Access Compliance Report

Public Rights-of-Way

Intersection ID: N/A	Main Street: SILVER_CRESCENT_DR	Cross Street: AYRSLEY_TOWN_BV	Location: SW
ADA ID: 0C6B8C9C4C06	Ramp Type: Perp	Initial Pass/Fail: Fail	Overall Compliance: No
Codes/Mitigation Info/Possible Solution		Field Measurements/Component Compliance	
Severity Score: 8.75

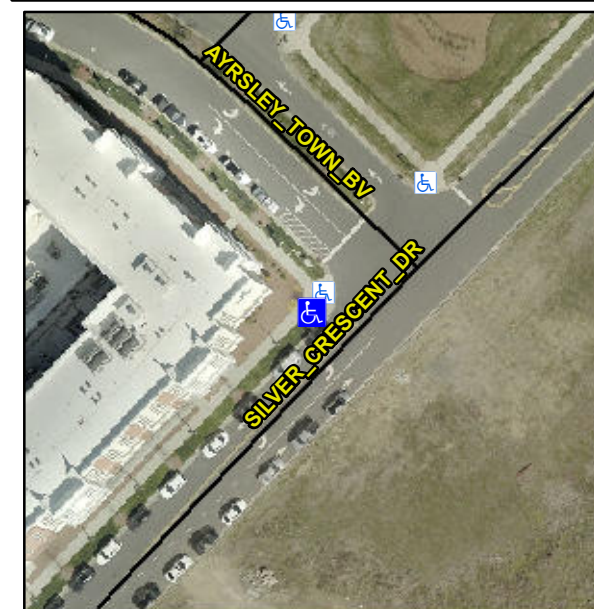
Not Found, R304.5.1

Compliance	Description	Data	Compliance	Description	Data
N/A	Ramp Length (in)	98.0	Yes	Ramp Slope (%)	7.0
No	Ramp Width (in)	47.0	Yes	Ramp XSlope (%)	0.6
N/A	Flare Type LT	N/A	N/A	Flare Type RT	N/A
N/A	Flare Slope LT (%)	N/A	N/A	Flare Slope RT (%)	N/A
N/A	Flare Traversable LT?	N/A	N/A	Flare Traversable RT?	N/A
N/A	Landing Length (in)	N/A	N/A	DWS Provided?	N/A
N/A	Landing Width (in)	N/A	N/A	DWS Contrast?	N/A
N/A	Landing Slope (%)	N/A	N/A	DWS Length (in)	N/A
N/A	Landing X Slope (%)	N/A	N/A	DWS Full Width?	N/A
N/A	Landing Curb? (Y/N)	N/A	N/A	DWS Offset (in)	N/A
N/A	Shared Landing?	N/A			
N/A	Gutter Ponding?	N/A	N/A	Gutter Slope (%)	N/A
N/A	Gutter Lip Ht (in)	N/A	N/A	Gutter X Slope (%)	N/A
N/A	Painted X Walk1?	No	N/A	Painted X Walk2?	N/A
	X Walk 1 Direction	To SE		X Walk 2 Direction	N/A
N/A	X Walk 1 Width (in)	N/A	N/A	X Walk 2 Width (in)	N/A
	X Walk 1 Slope (%)	5.8		X Walk 2 Slope (%)	N/A
	X Walk 1 X Slope (%)	2.2		X Walk 2 X Slope (%)	N/A

Remove & Replace Entire Ramp.
